**First Revision No. 1051-NFPA 13-2022 [Global Input]**

First Revision No. 1341-NFPA 13-2022 [Global Input]

Figure 8.6.3.3 Arrangement of Supply Piping with Backflow Device.

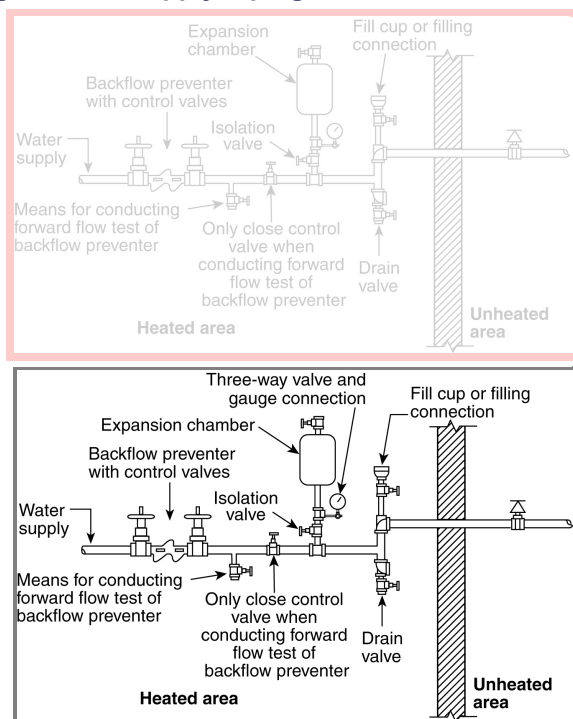
Committee Statement: Add "call-out" of 3 way valve as it was added last cycle and not called out on detail.

Figure 8.6.3.4 Arrangement of Supply Piping with Relief Valve and Backflow Device.

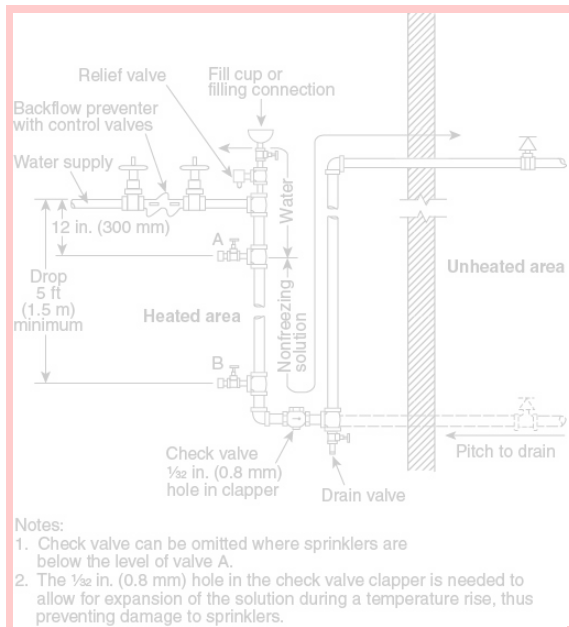
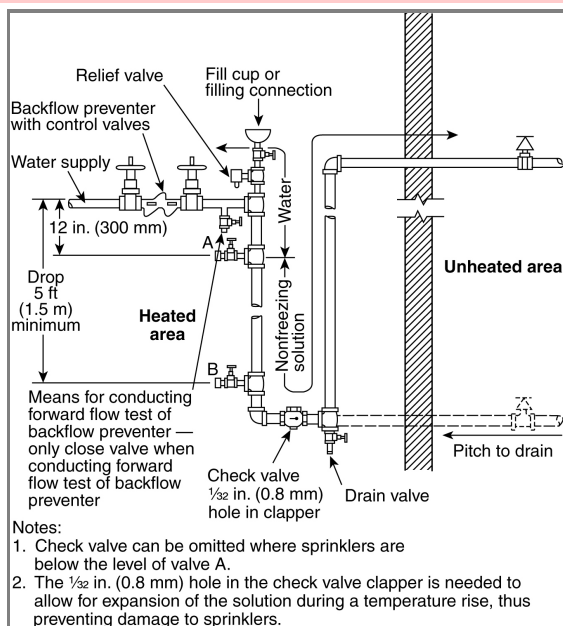
Committee Statement: Figure 8.6.3.3 shows the needed connections to perform a forward flow test of a backflow preventer when a backflow preventer is installed. However, Figure 8.6.3.4 lacks this test connection. This figure needed to be modified to show and describe this connection.

Figure 9.4.2.5 High-Temperature and Intermediate-Temperature Zones at Unit Heaters and Radiant Heaters.

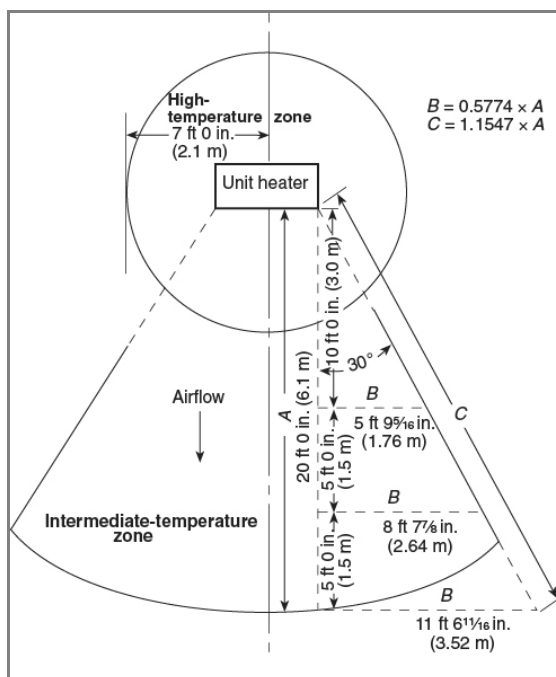
Committee Statement: Adding the words “from edge” provides clarity and matches figure 9.4.2.5. LED lights put off less heat and do not have enough heat to activate a sprinkler. Adding “except LED” also correlates with proposals accepted with NFPA 13R and NFPA 13D.

Figure 10.3.6.1.7 Sprinkler Obstruction in Hallways (Standard Spray Sidewall Sprinklers).

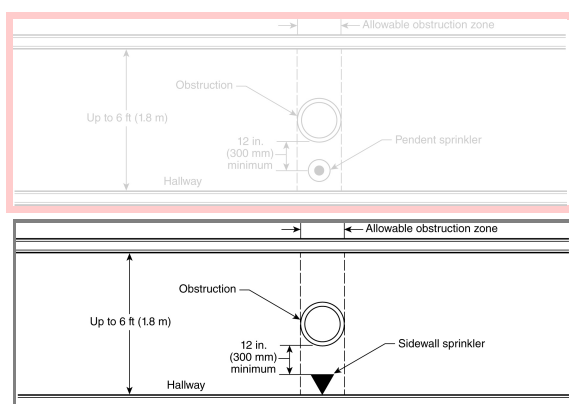
Committee Statement: Correct figure 10.3.6.1.7 to show a sidewall sprinkler.

Figure 11.3.6.1.4(d) Obstruction in Hallway (Extended Coverage Sidewall Spray Sprinklers).

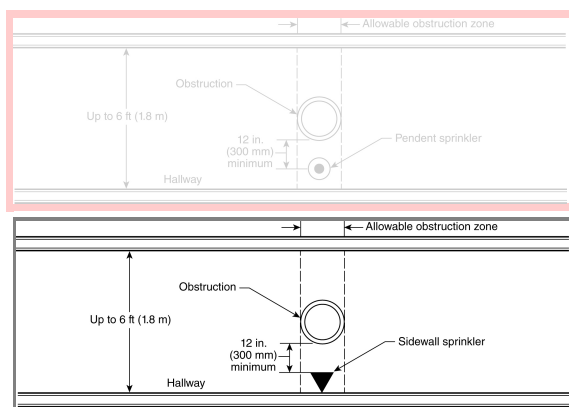
Committee Statement: Figure 11.3.6.1.4(d) currently shows a pendent sprinkler which should be a sidewall sprinkler. This corrects the figure by removing the pendent and adding a sidewall.
Response Message: FR-1230-NFPA 13-2022

Figure 12.1.7.6 Sprinkler Spacing with Sloped Ceilings.

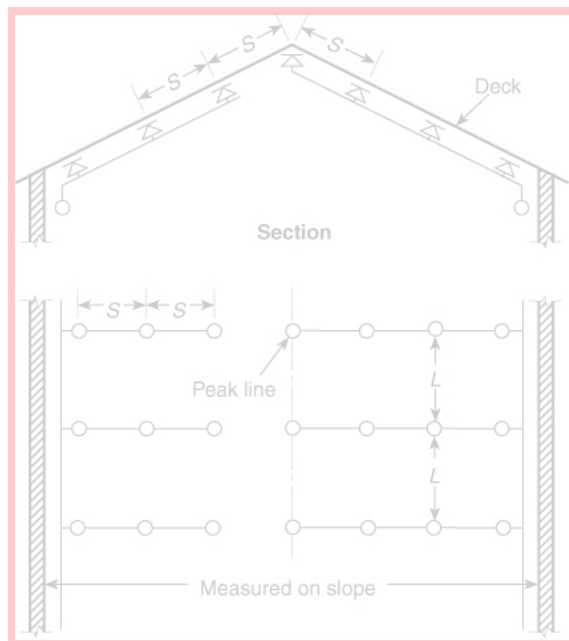
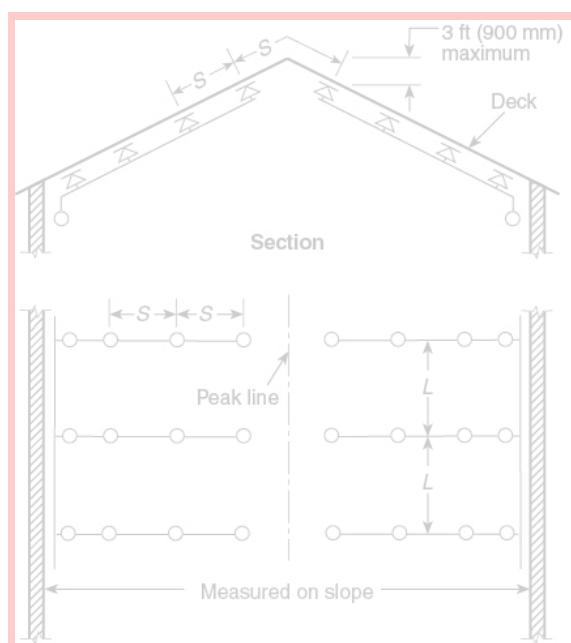
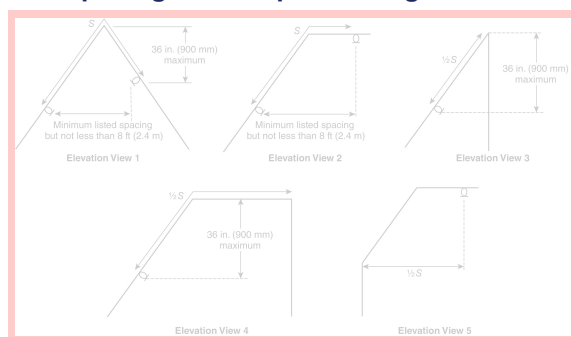
Committee Statement: Move figure 12.1.7.6 to 12.1.7.5 and replace the current figures 12.1.7.5(a) and 12.1.7.5(b). The figures shown in existing section 12.1.7.6 more accurately depict sprinklers near the peak.

Figure A.9.4.2.5(a) Ordinary-Temperature Sprinkler over Recessed Fireplace.

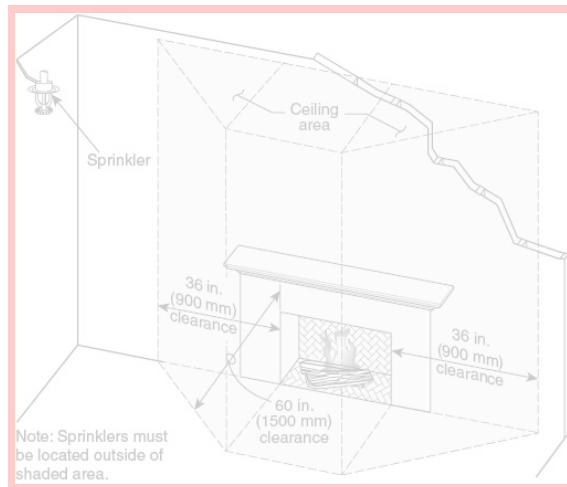
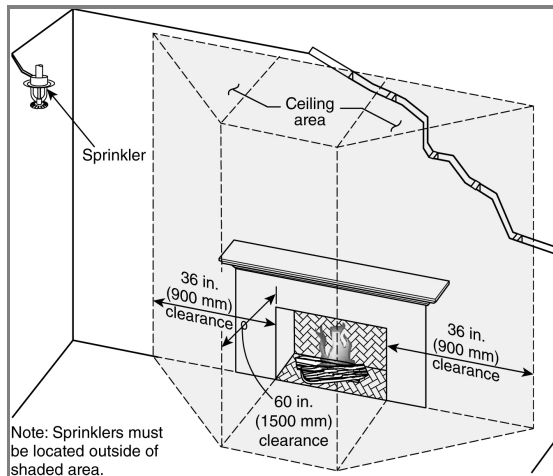
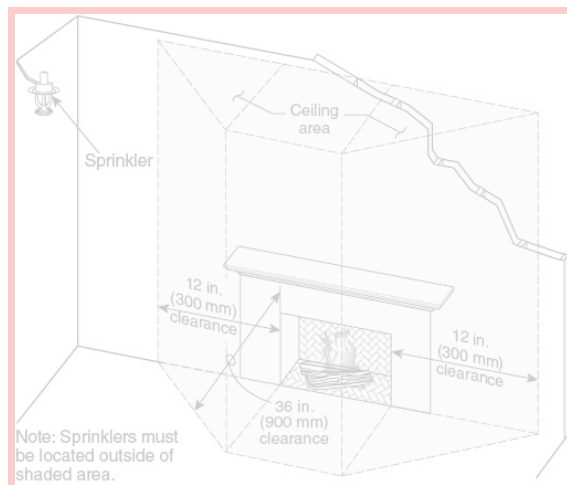
Committee Statement:	The current dimension line for Figure 9.4.2.5(a) and Figure 9.4.2.5(b) are incorrect. This corrects the dimension line for the 36" arrow and the 60" arrow. The figures in 13R and 13D were both corrected during the first draft meeting.
Response Message:	FR-1250-NFPA 13-2022

Figure A.10.2.5.2.3(a) Small Room Provision — One Sprinkler.

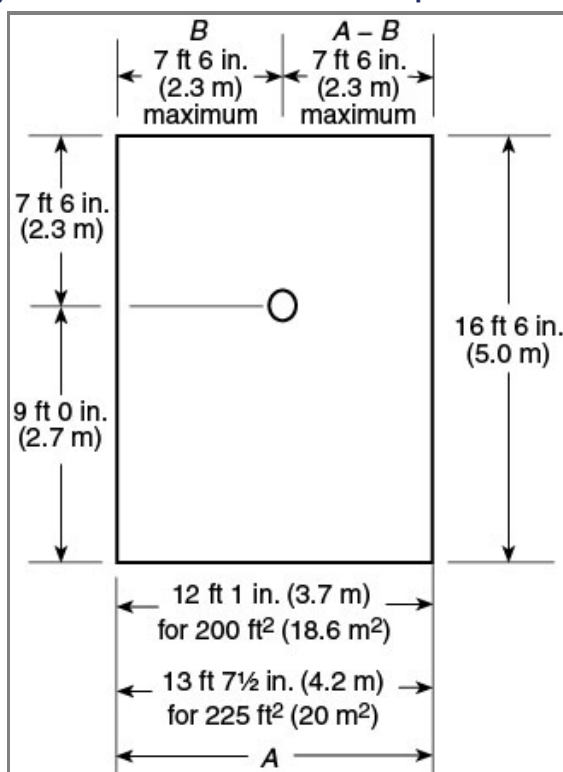
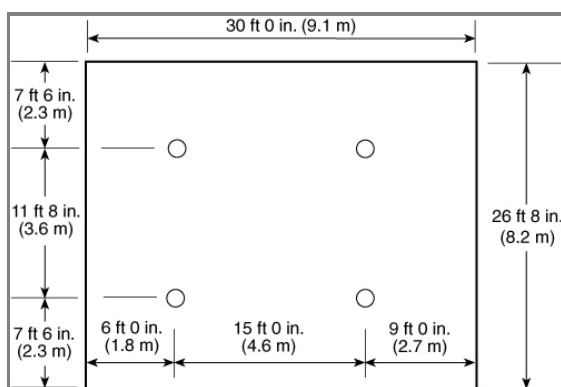
Committee Statement: The added statement will help understanding and applying figures A.10.2.5.2.3(a) and A.10.2.5.2.3(d).
